CHANGE ORDER

PROJECT NAME: Edward A. Dufresne Community Center CHANGE ORDER NO: 001
 PPG OCD-DR PROJECT NUMBER: 45PARA3201
 CONTRACTOR: Lamar Contractors, Inc. CONTRACT DATE: 12-7-11

Subject: St. Charles Parish- Community Center
Gustav/Ike Project Number 45PARA3201
Review of Construction Change Order No. 1

drawing number	ASK006
project number	21131.00
date	06-12-12
file name	ASK006.dwg
issued for	WCPR #06
this drawing modifies:	A201

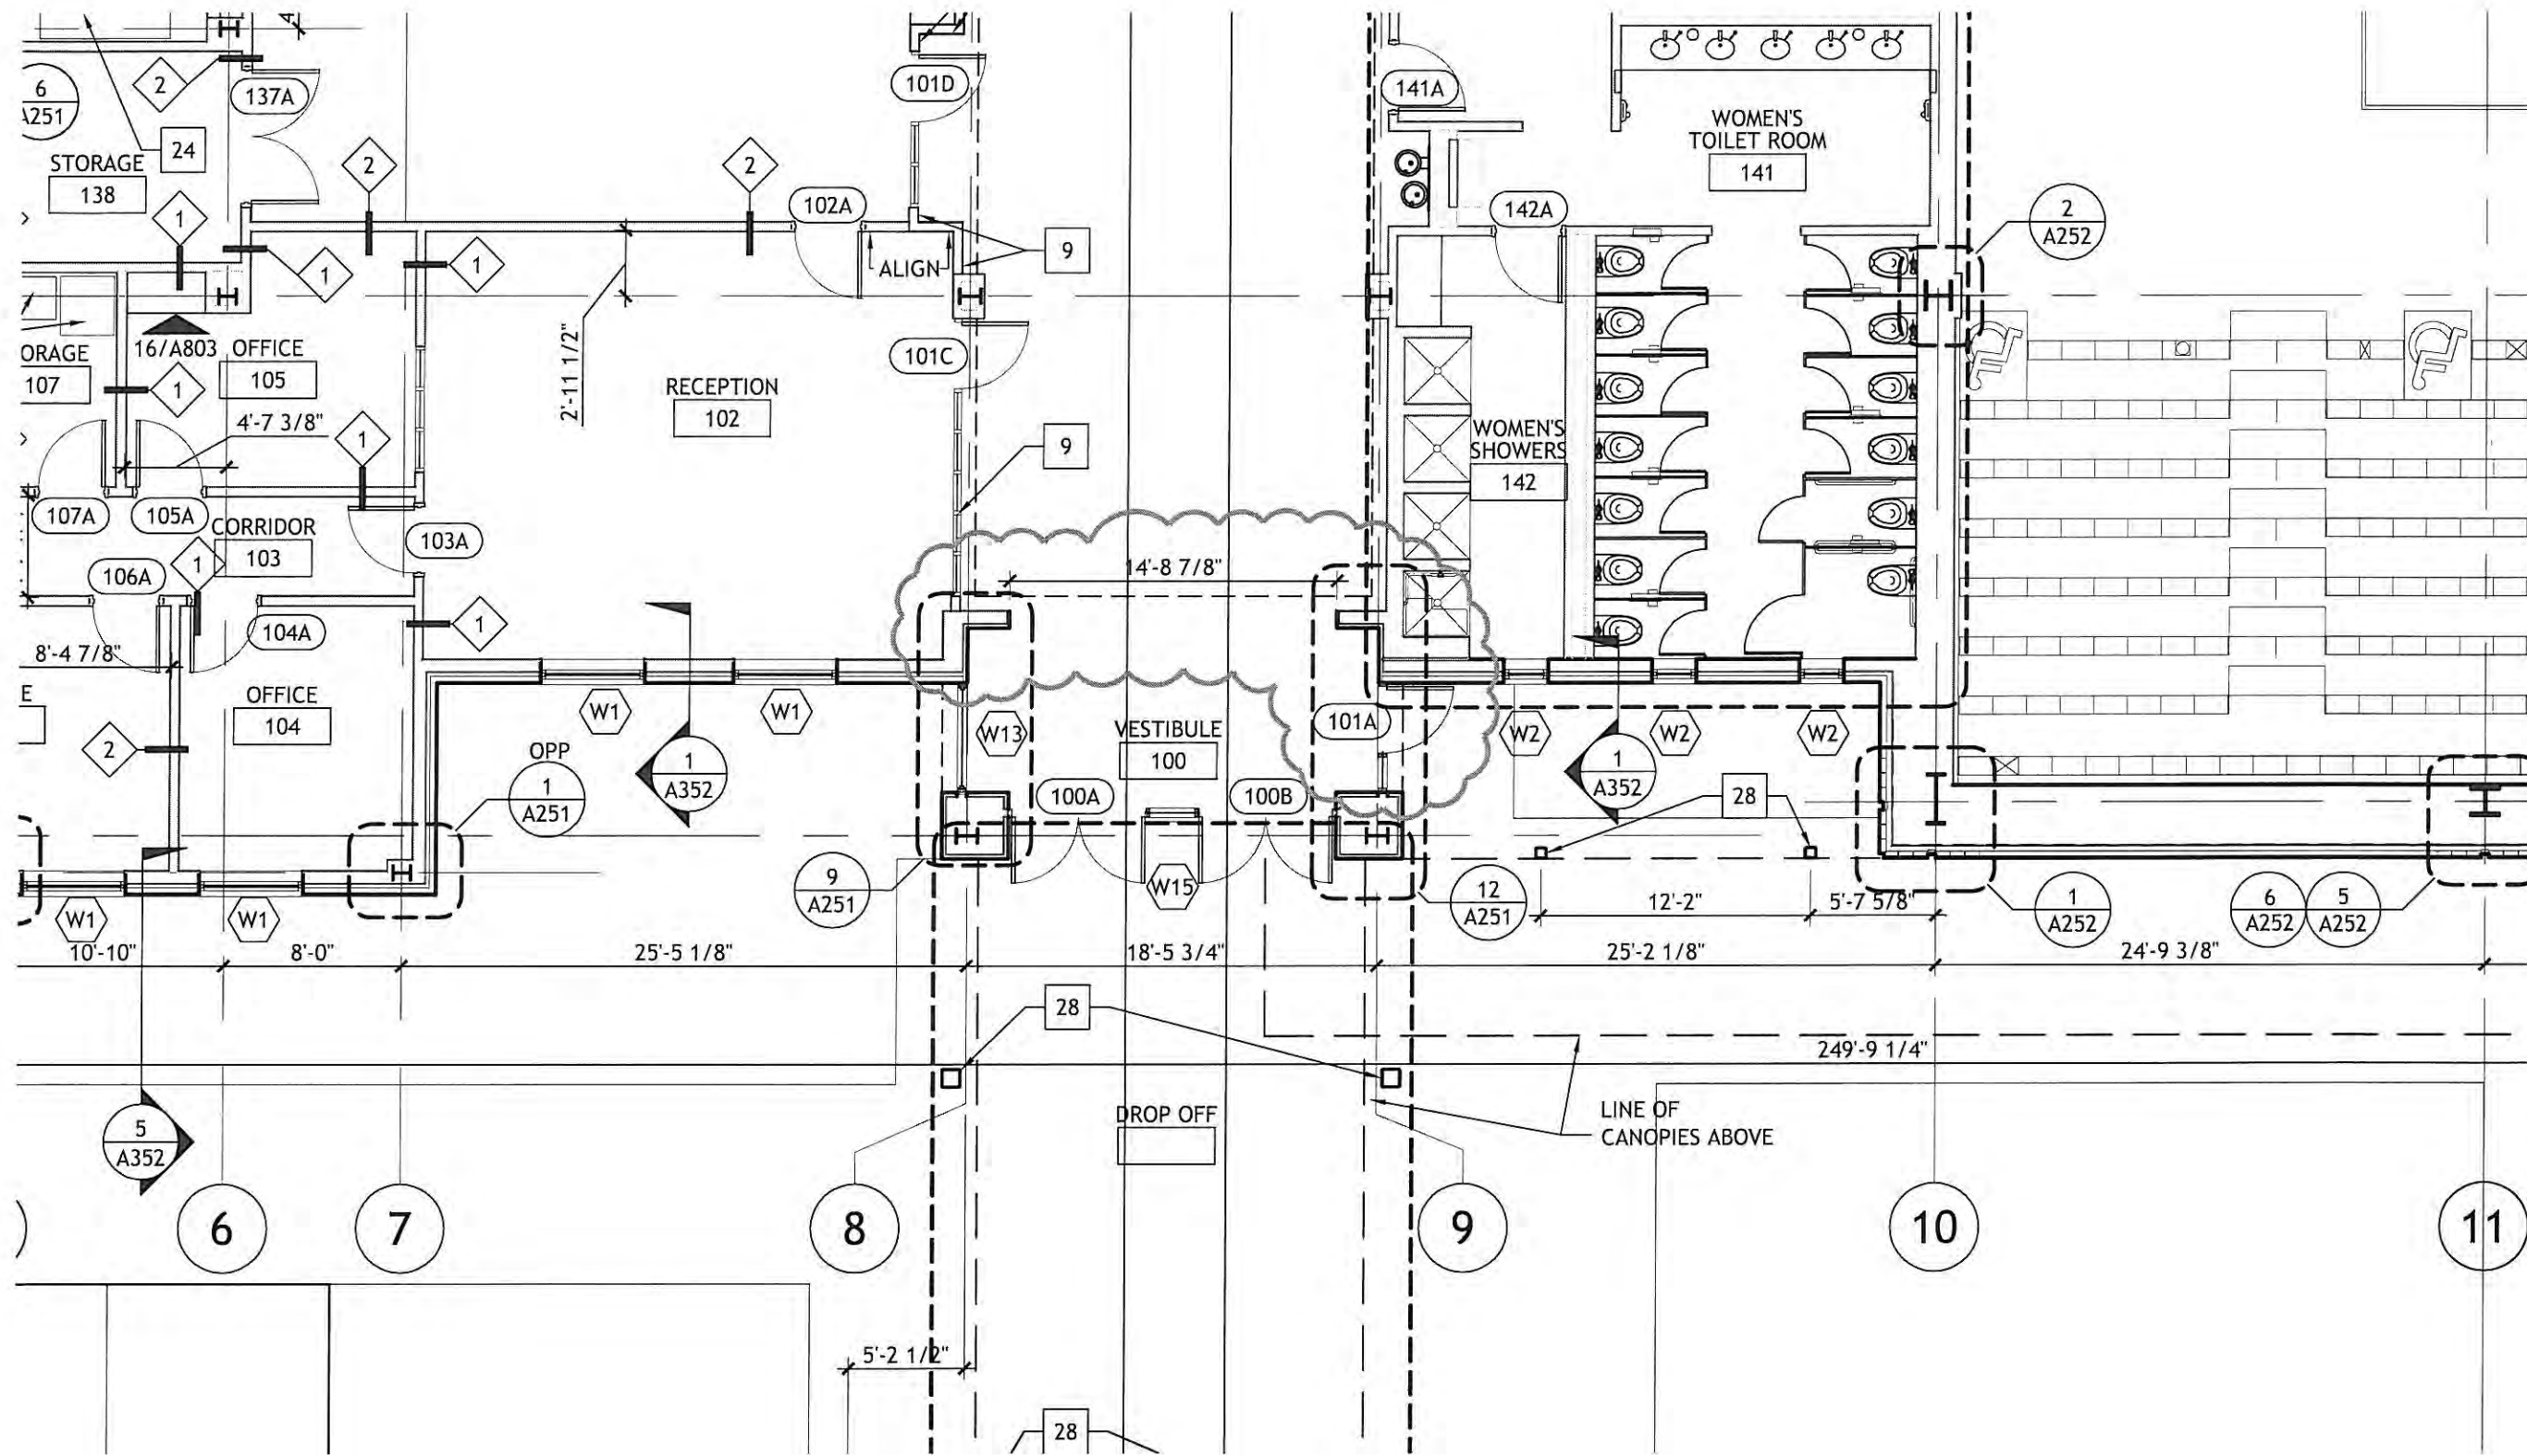
Delete doors 101A and door 101B and window W10 in its entirety. Replace in lieu thereof with door 101A as shown on attached sketch ASK006 and ASK007.

project number 21131.00	date 06-12-12	drawing number ASK007
file name ASK007.dwg	issued for WCPR #006	this drawing modifies: A351

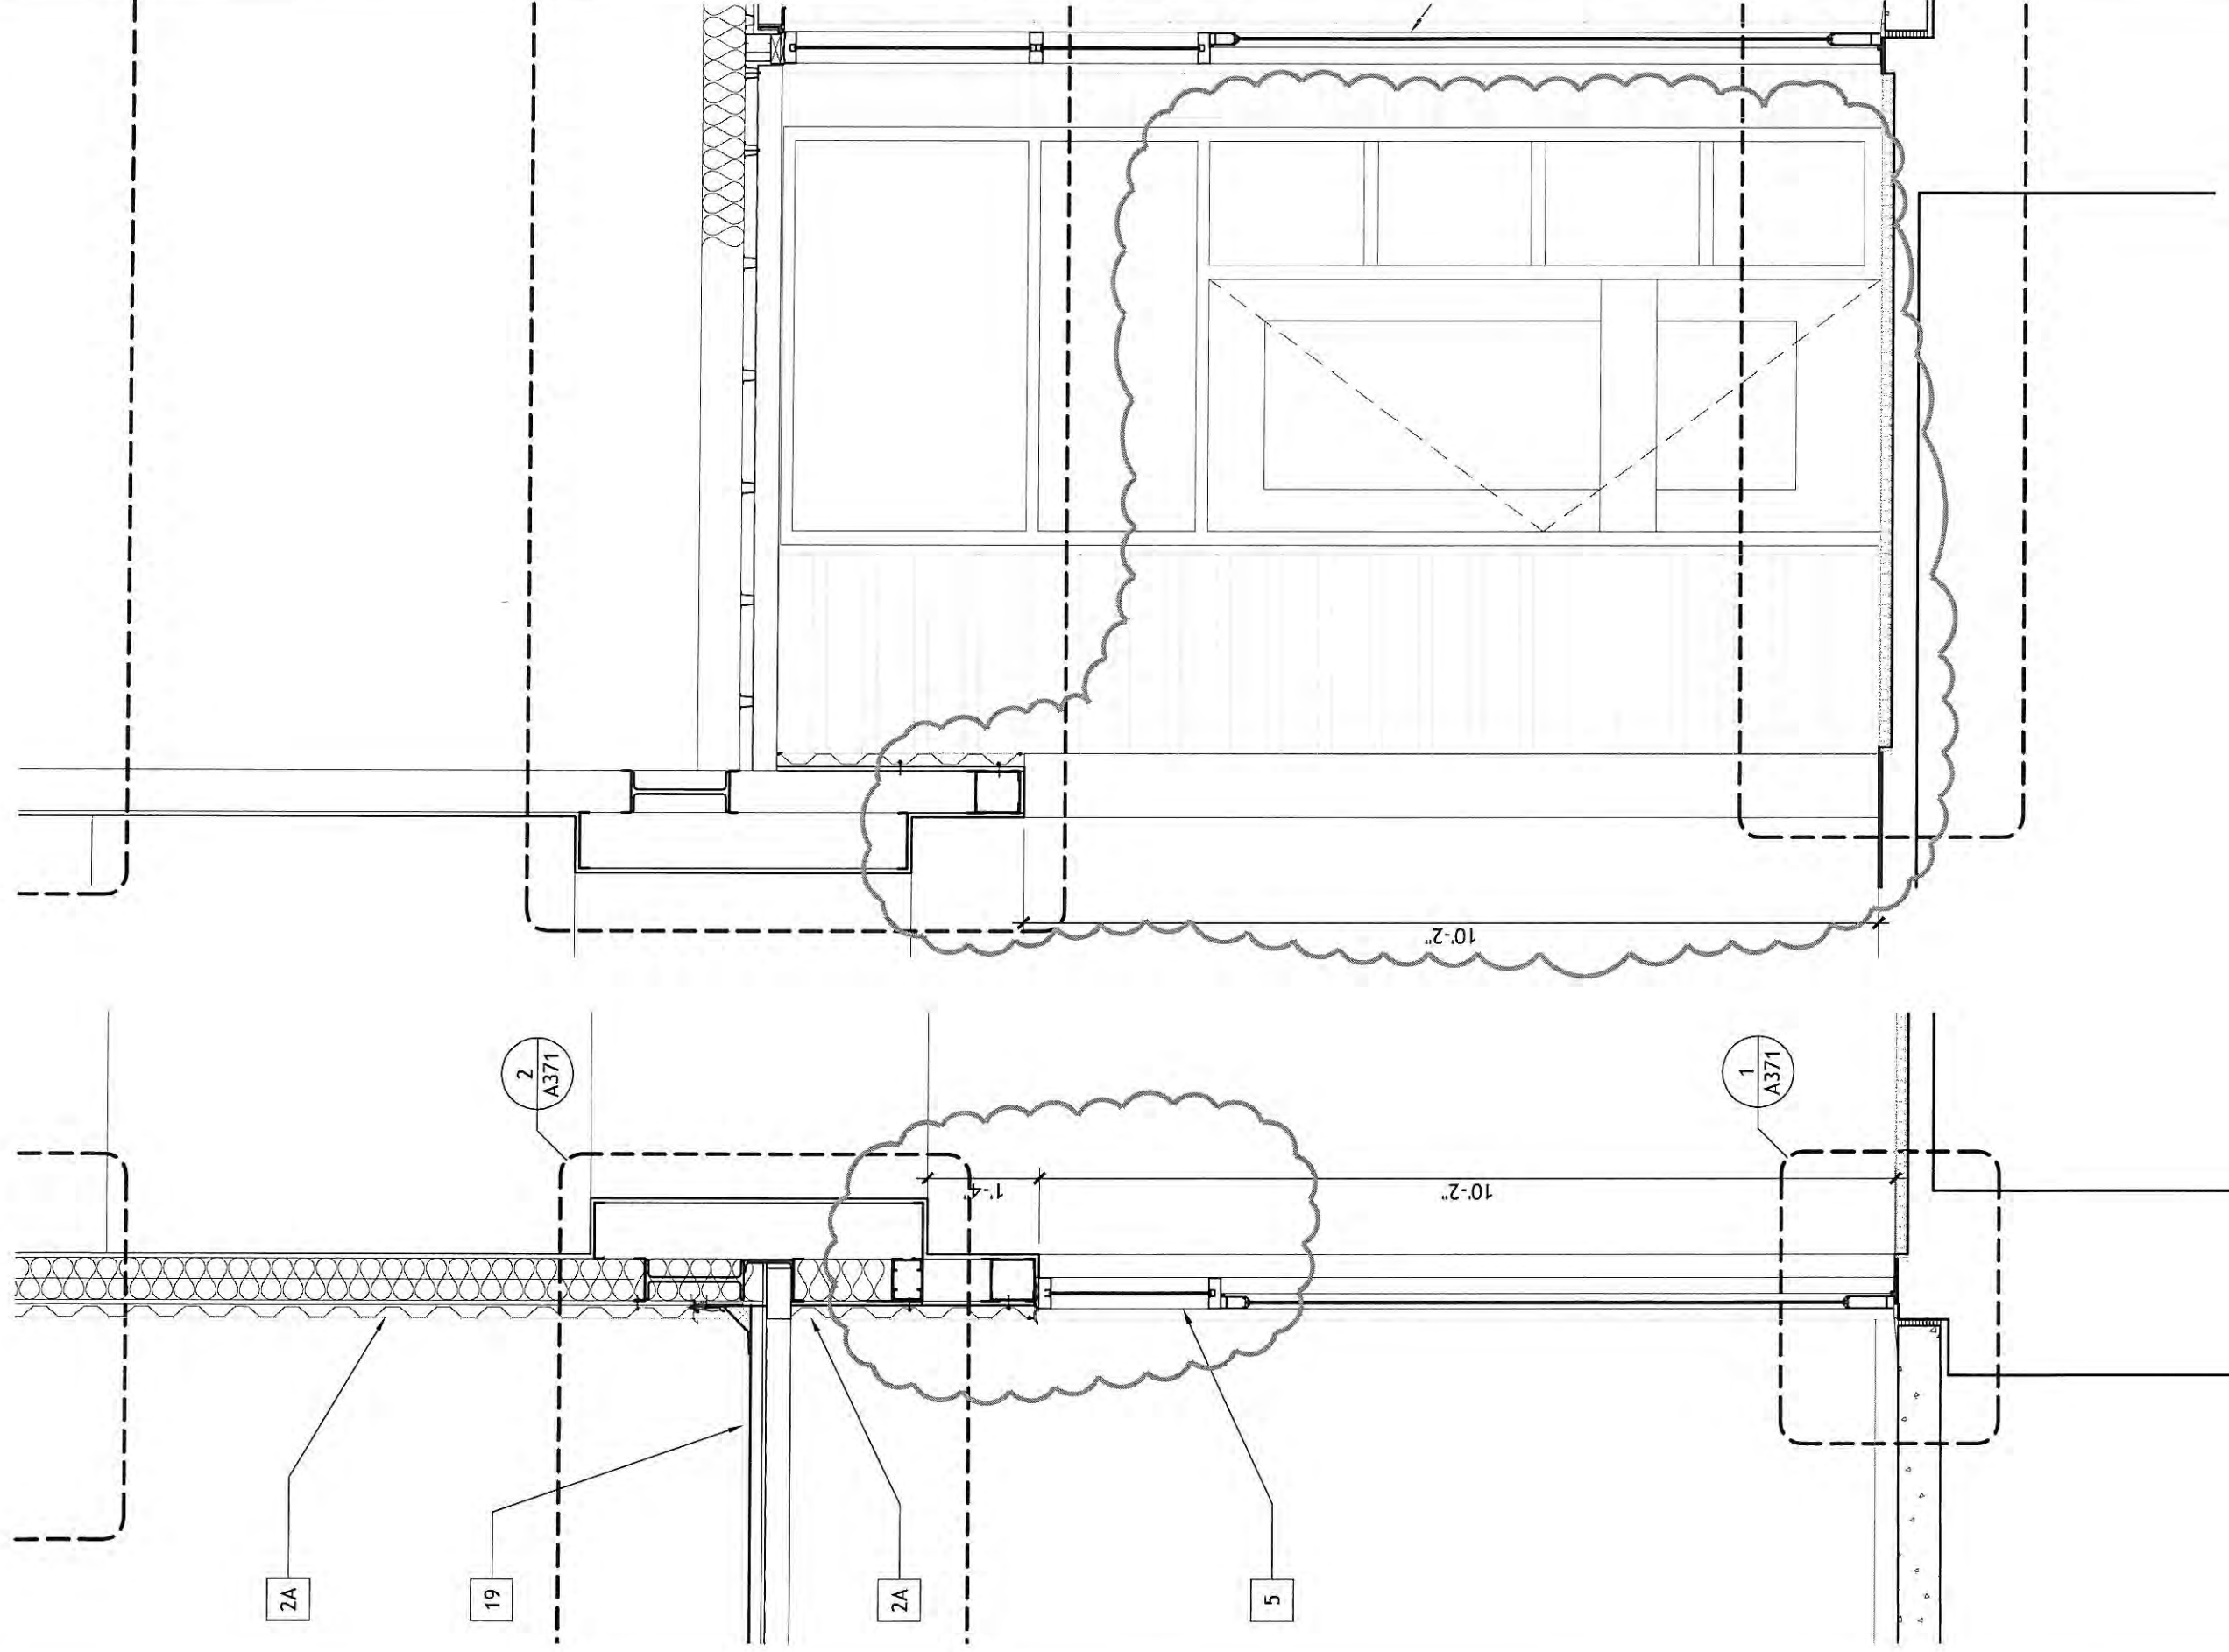
Modify window W9 in revised section 1/A351 as shown on attached sketch ASK007.
